**Publication of EMF-92-081(P)(A) Revision 1, "Statistical Setpoint/Transient Methodology for Westinghouse Type Reactors"**

EMF-92-081(NP)(A)  
Revision 1

## Statistical Setpoint/Transient Methodology for Westinghouse Type Reactors

**GENERAL QUESTIONS PERTAINING TO BOTH**  
**THE WESTINGHOUSE AND COMBUSTION ENGINEERING**  
**STATISTICAL SETPOINT/TRANSIENT METHODOLOGY**

**Figure 2.1 Calculational Flow for OPΔT Confirmation**

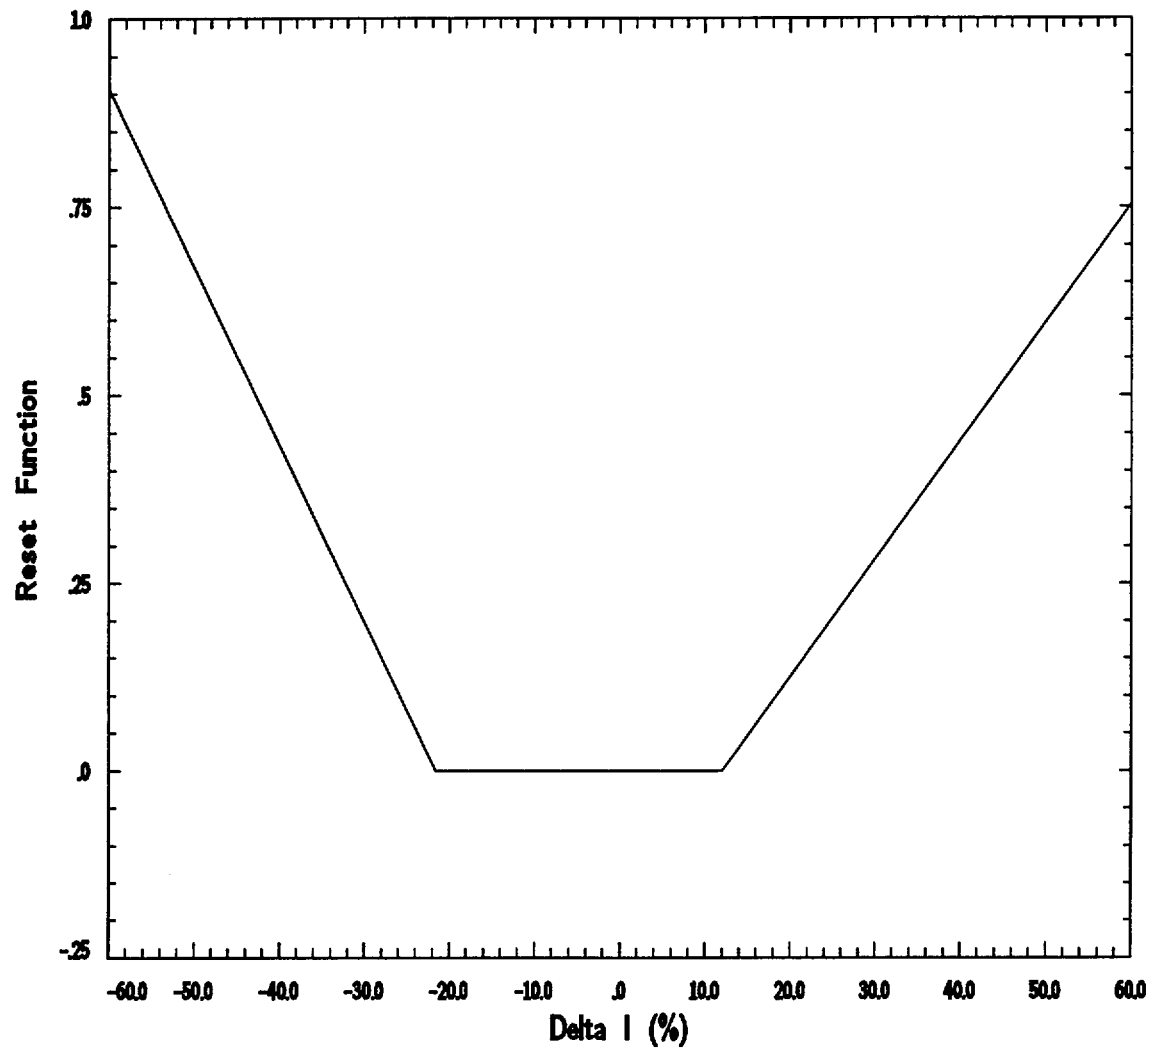
It is stated that in the confirmation of the  $OP_{\Delta T}$ , a scan is performed to locate the minimum margin. Please describe how the scan is performed and if a matrix of the parameters used in the scan is generated, please provide it.

***It is stated that in the confirmation of the  $OP\Delta T$ , a scan is performed to locate the minimum margin. Please describe how the scan is performed and if a matrix of the parameters used in the scan is generated, please provide it.***
